### **ADDENDUM #3**

#### **Rye City School District**

***Issued: 2021-02-11***

**This Addendum No. 3 forms part of the Contract Documents and modifies the original bidding documents dated, January 19, 2021.**

SCALE: 1" = 1'-0"

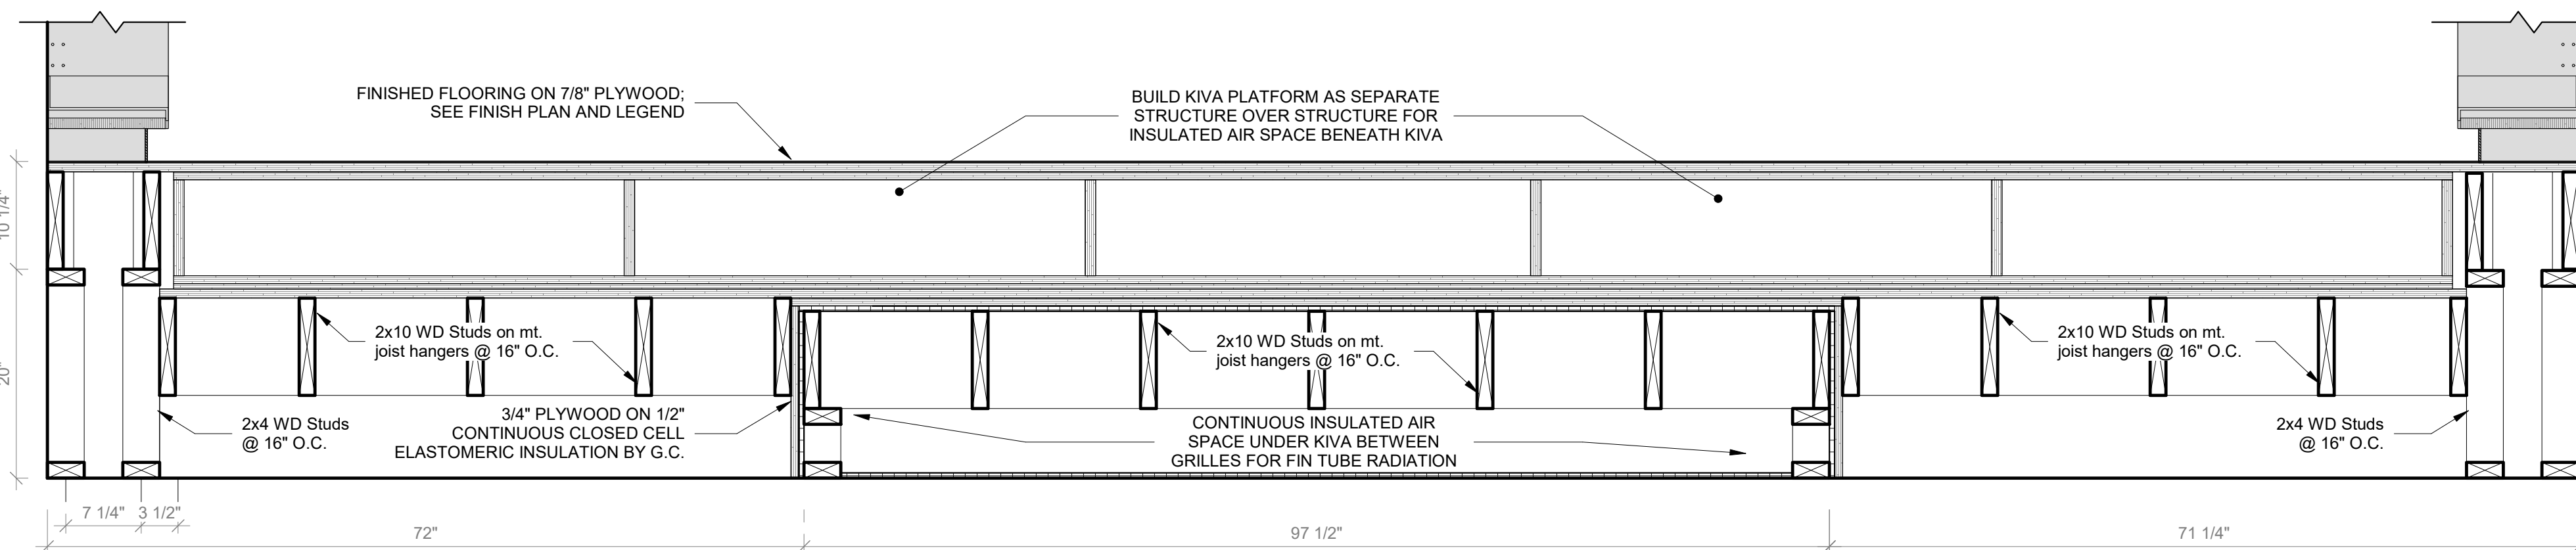
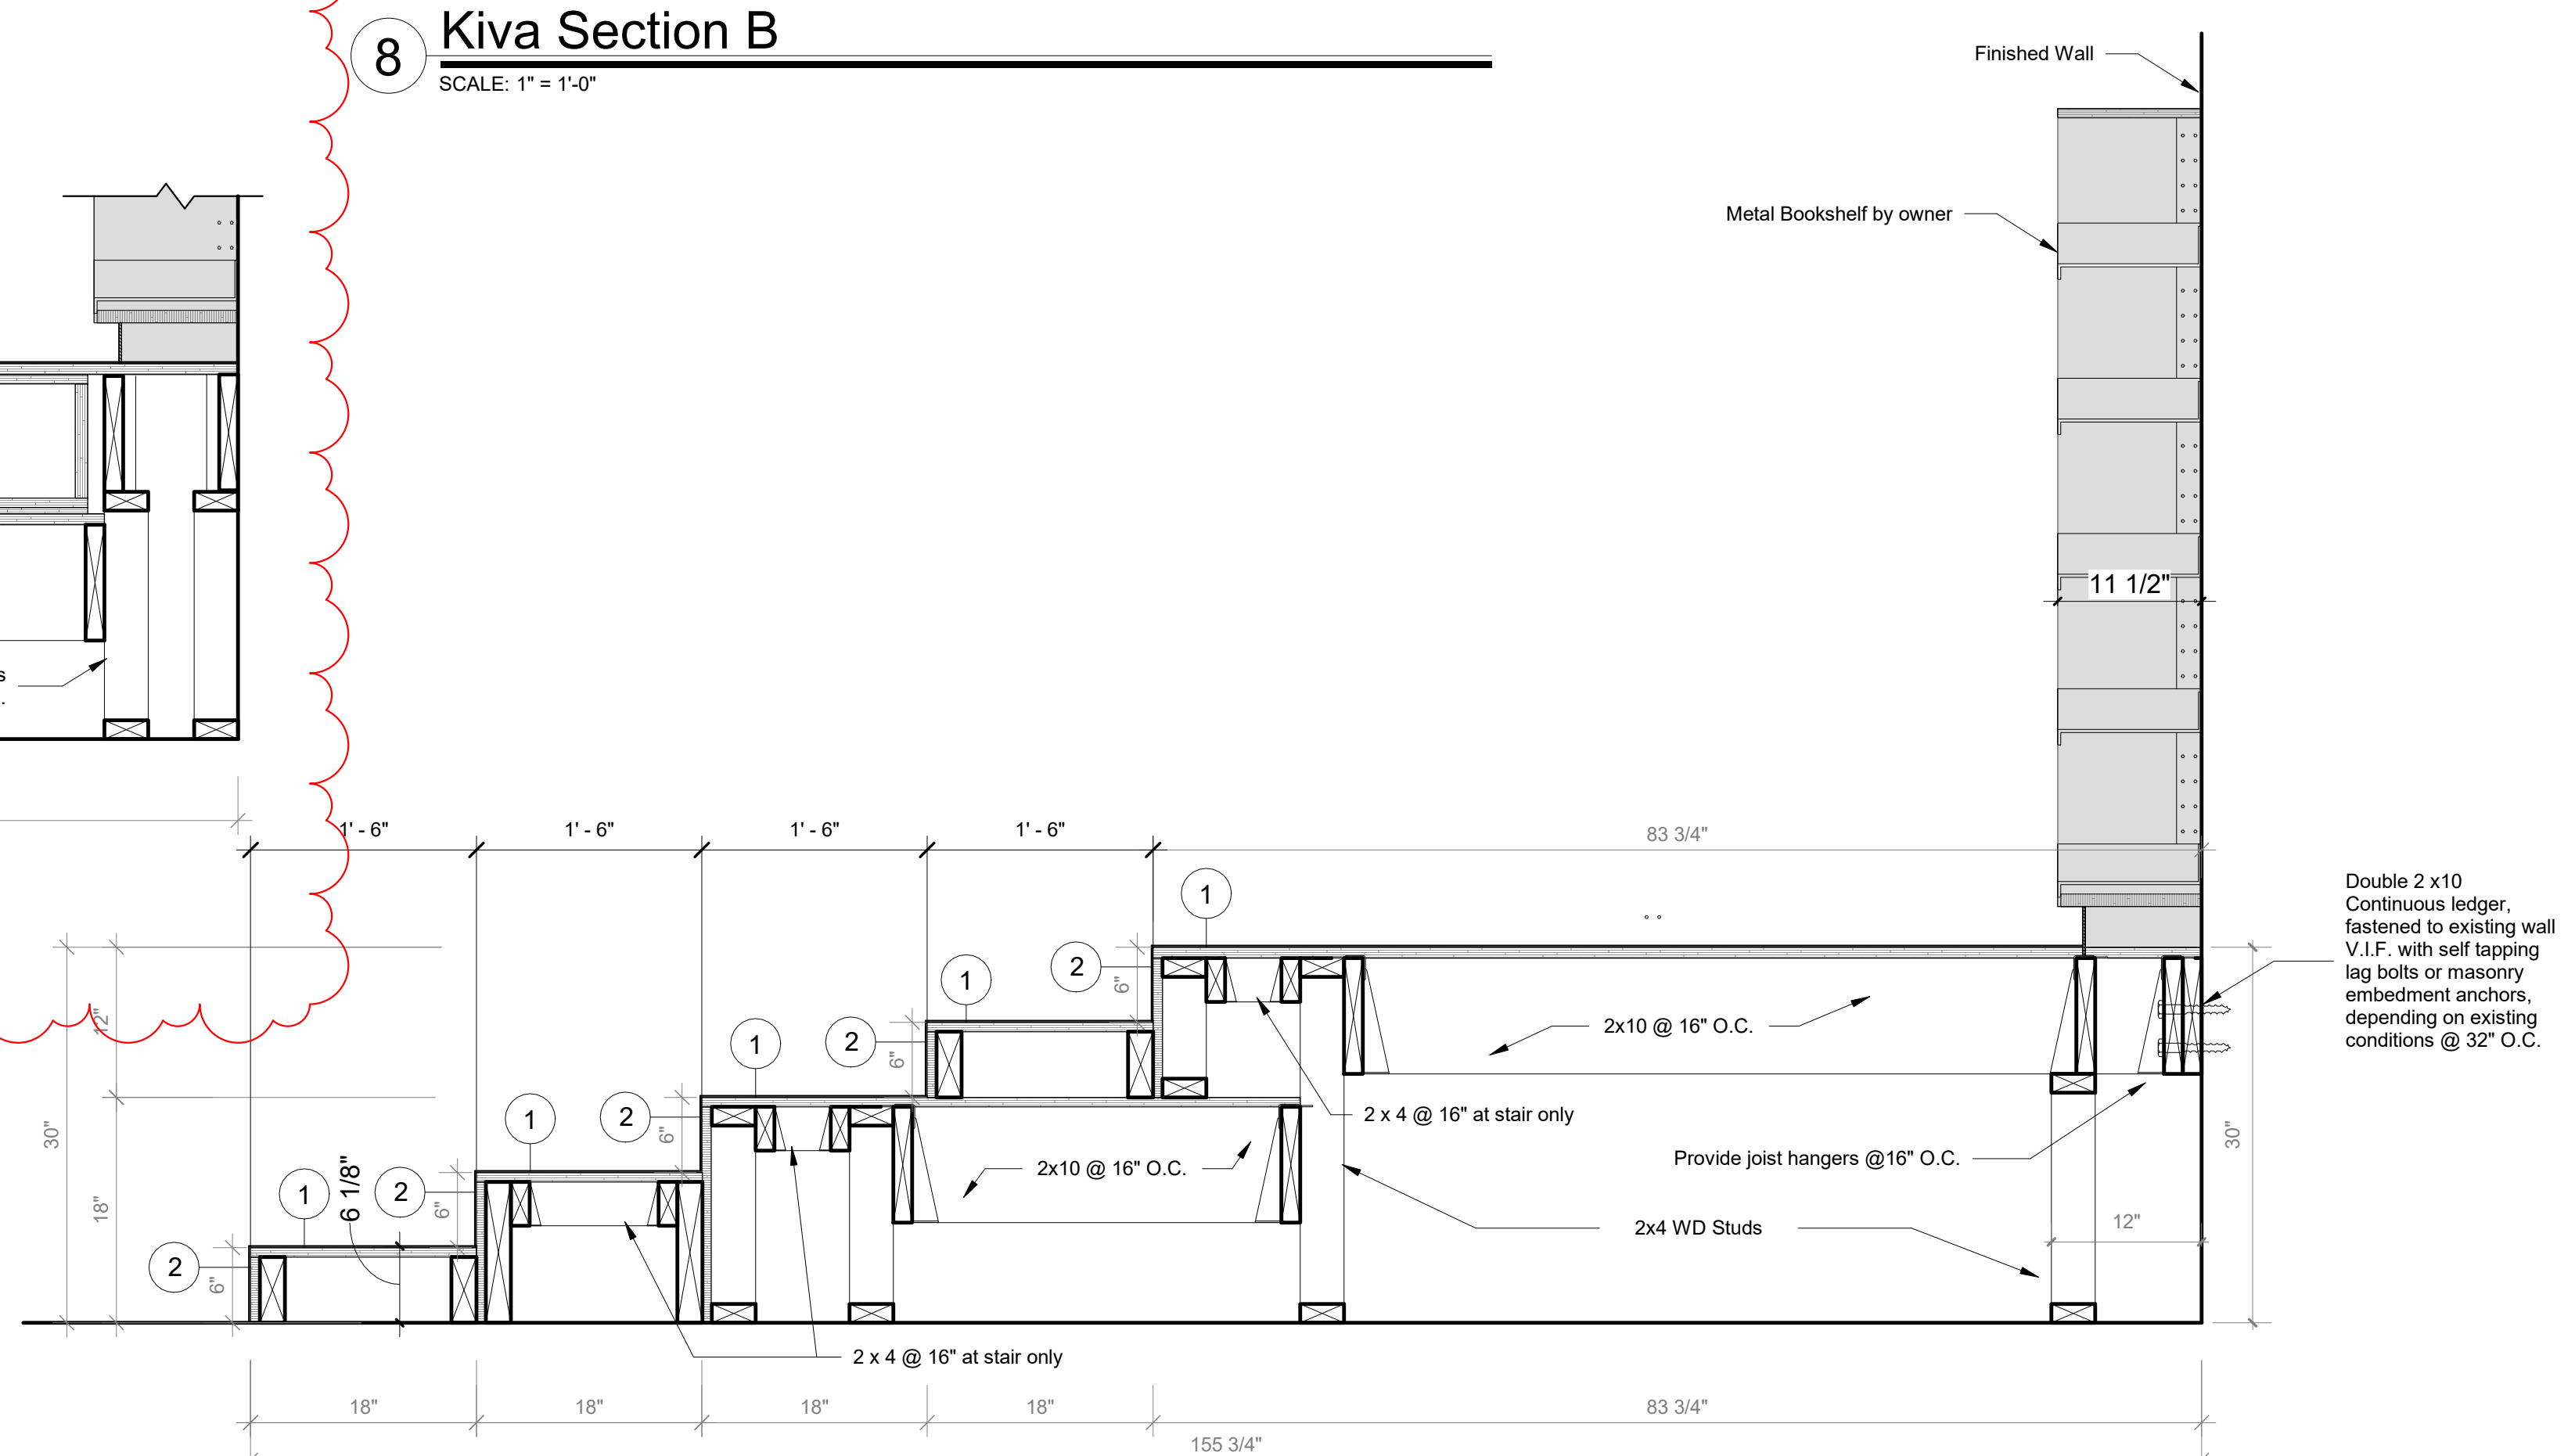
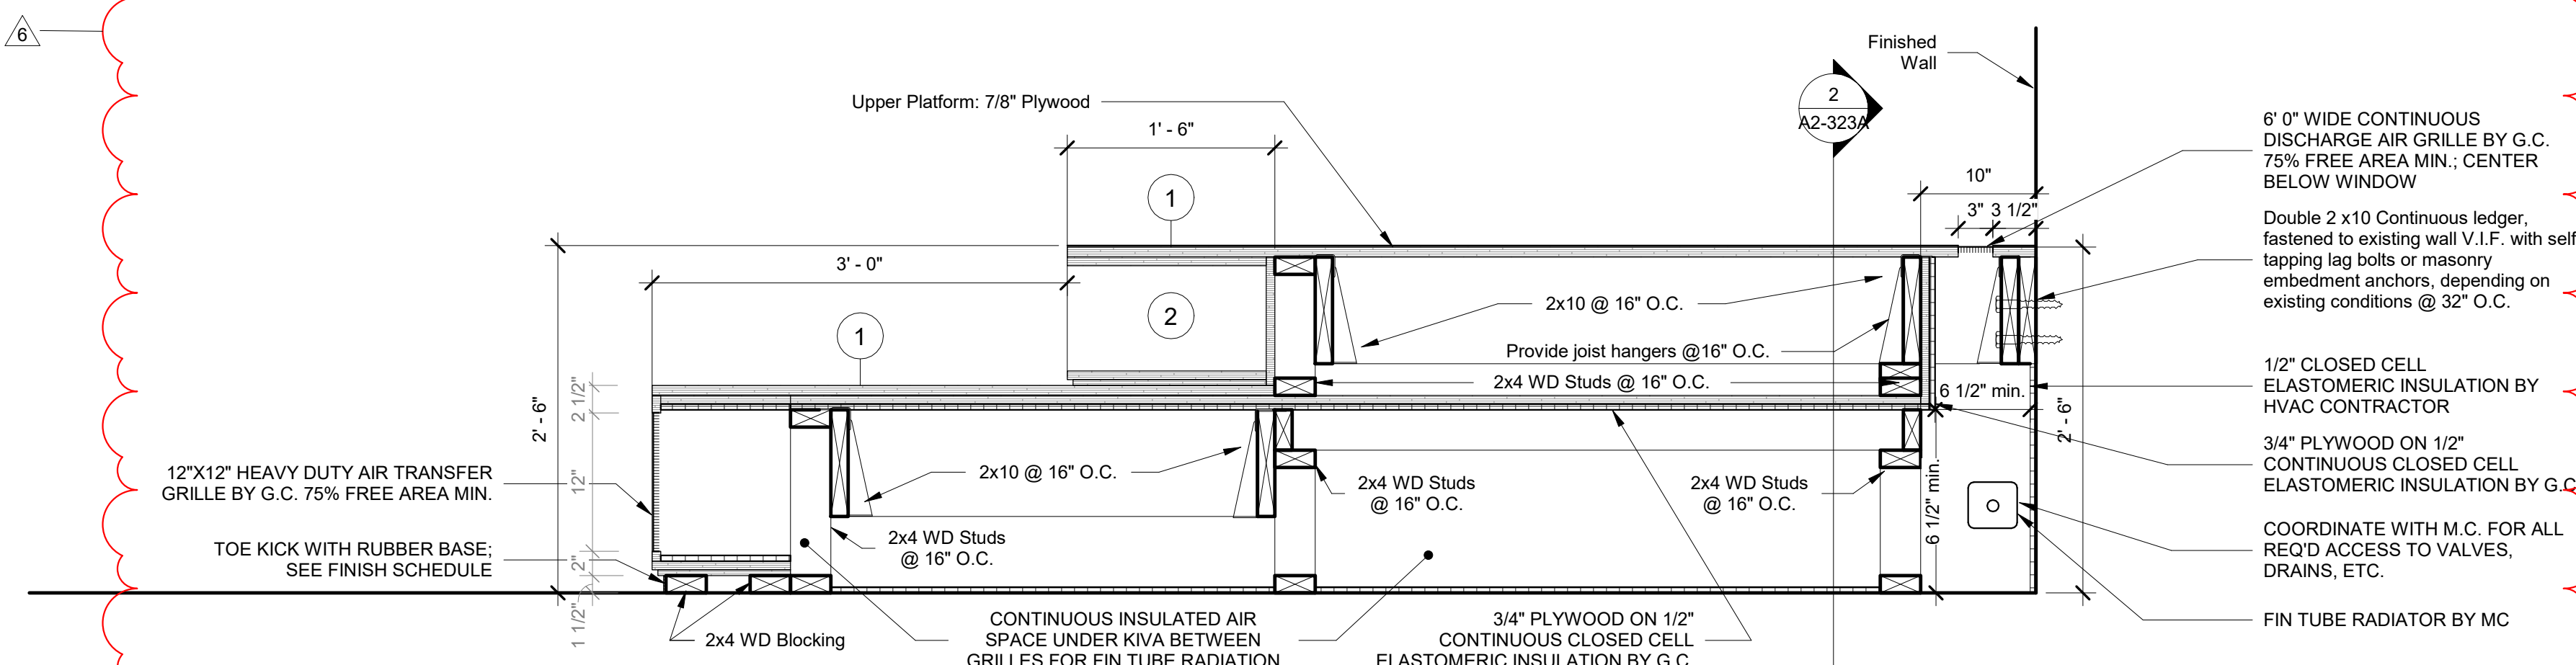
- a. Detail 5 eliminated, as it is redundant. Kiva Section C revised. Kiva Section D and Kiva Section E added for clarification. Sheet re-arranged and re-numbered.

SEAL & SIGNATURE | DATE: 2/11/2021  
PROJECT No: 9200  
DRAWING BJMM/MDDB  
CHK BY: MJM  
DWG No: AVE2-101

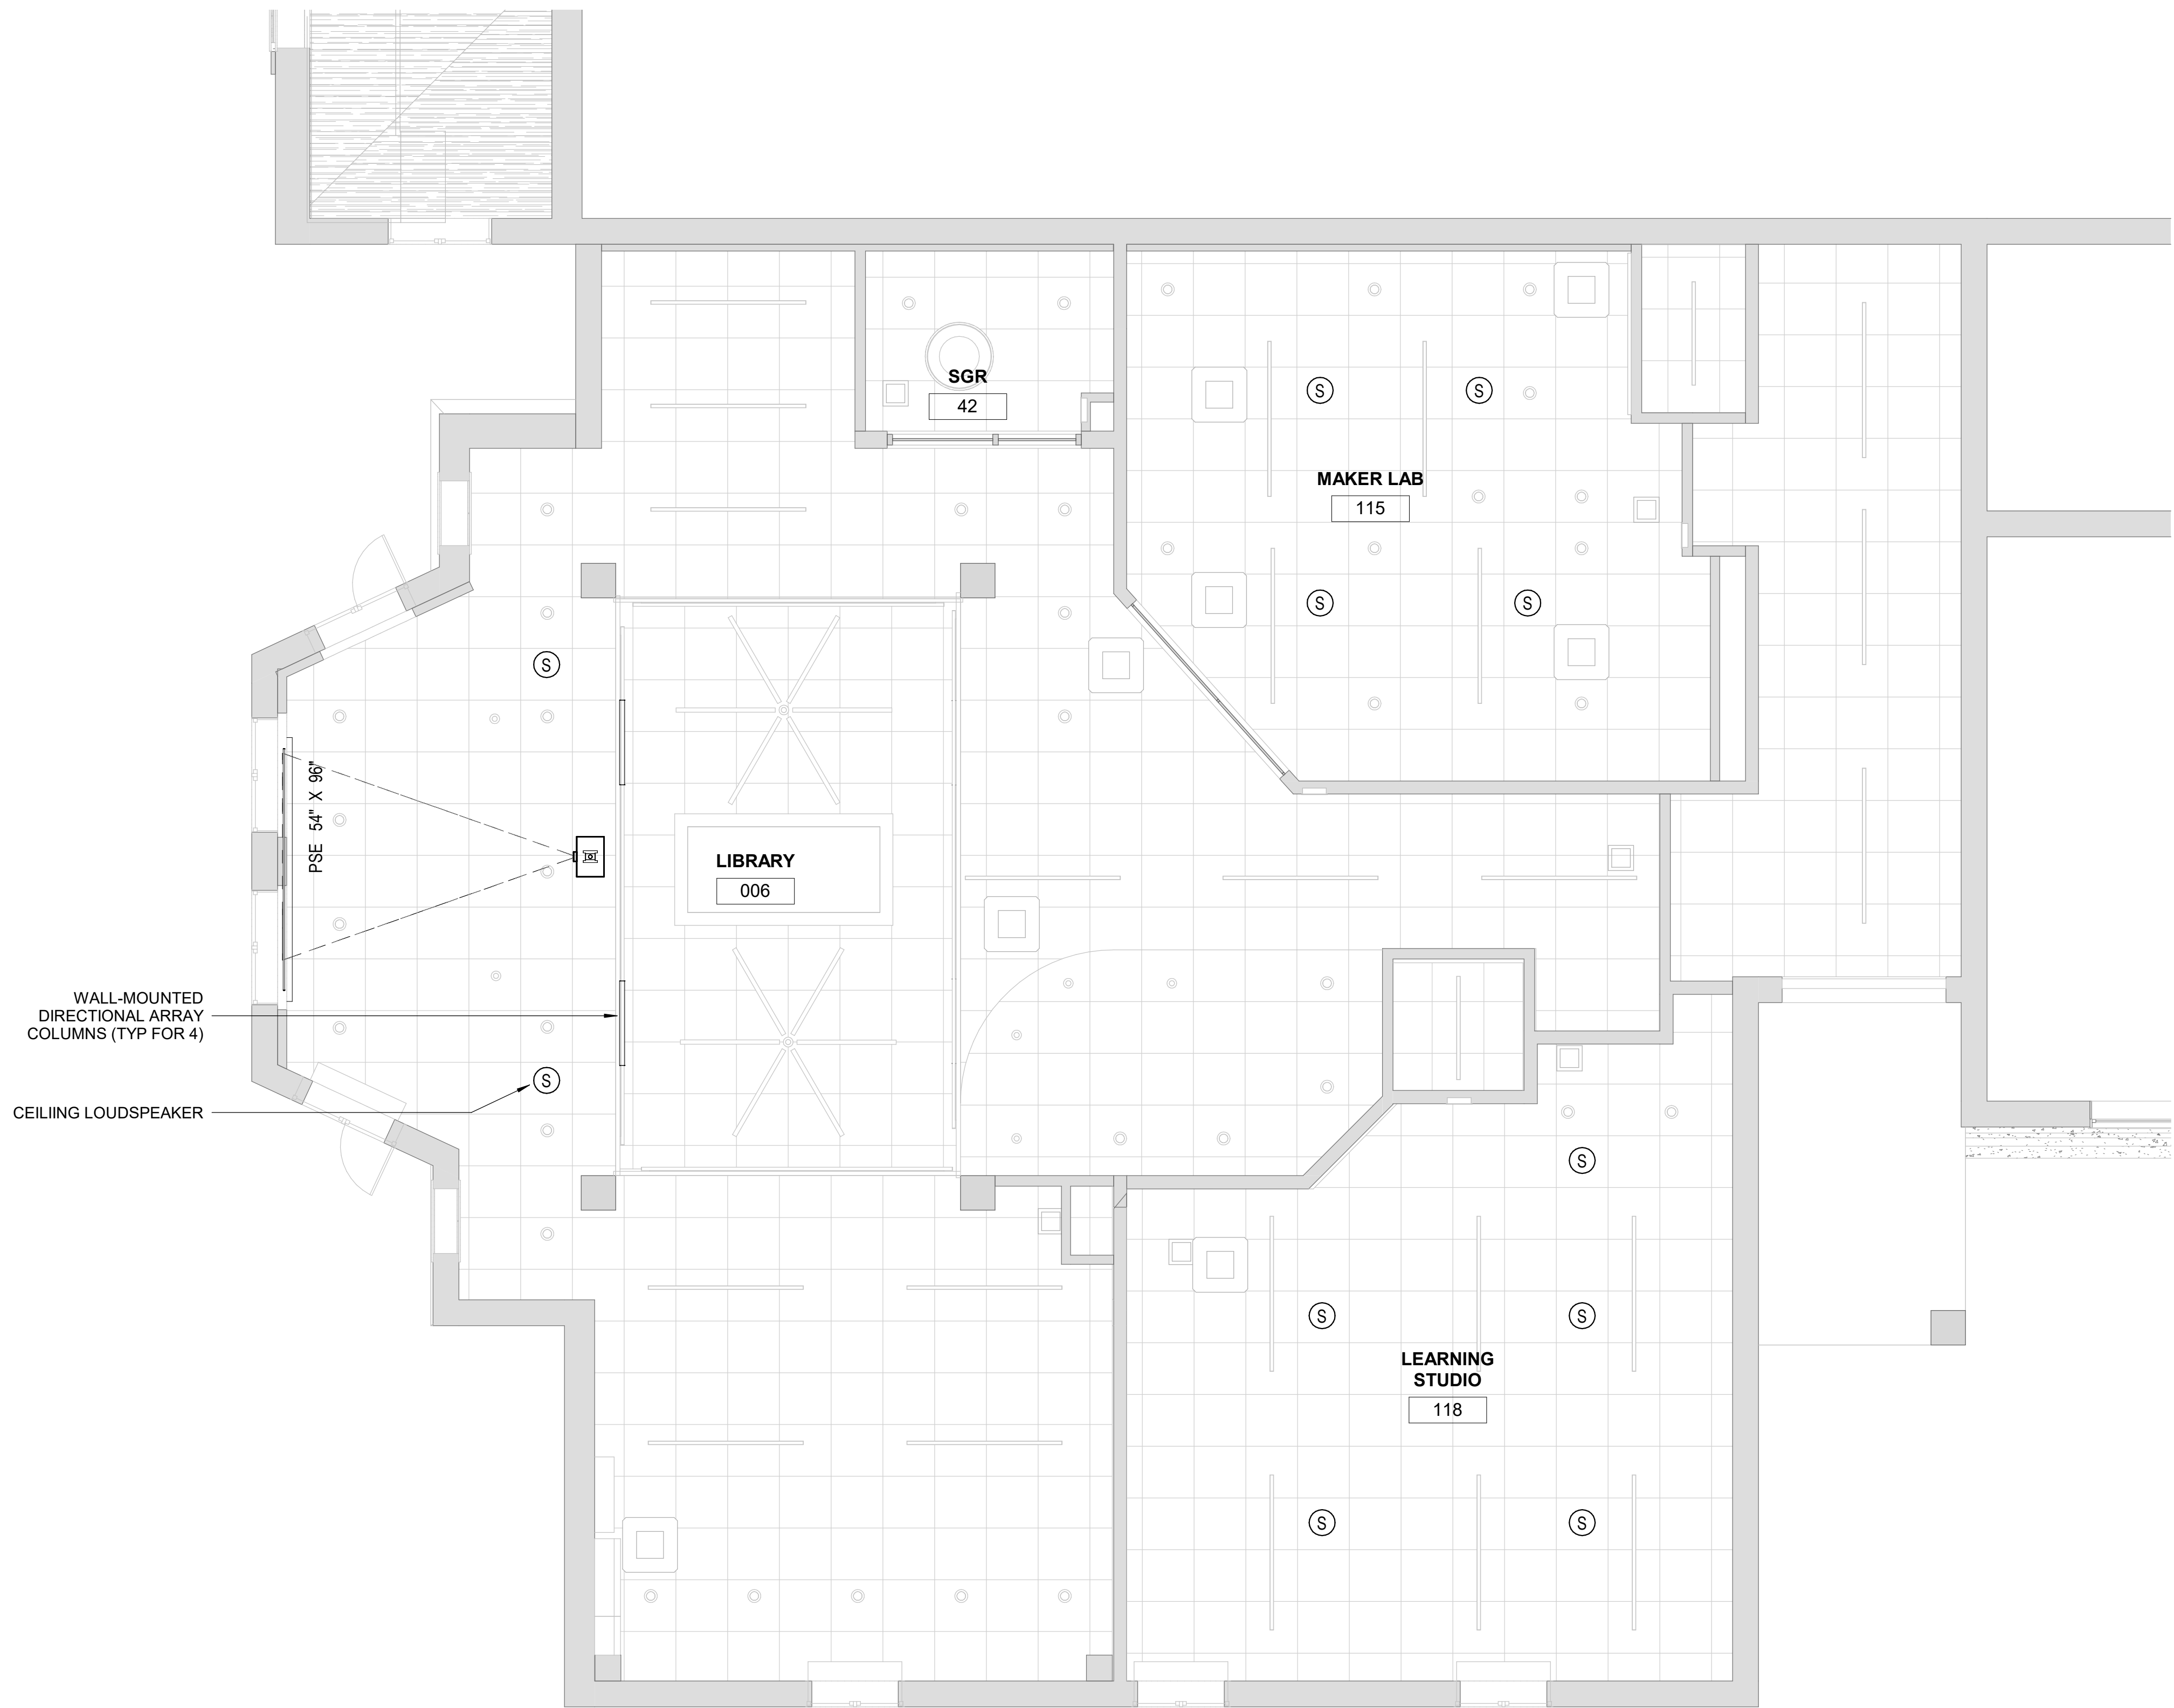
17. AVE2-101
  - a. Notes have been added to these drawings to clarify the scope of work between EC and Owner's AV vendor.
18. AVE2-102
  - a. Notes have been added to these drawings to clarify the scope of work between EC and Owner's AV vendor.
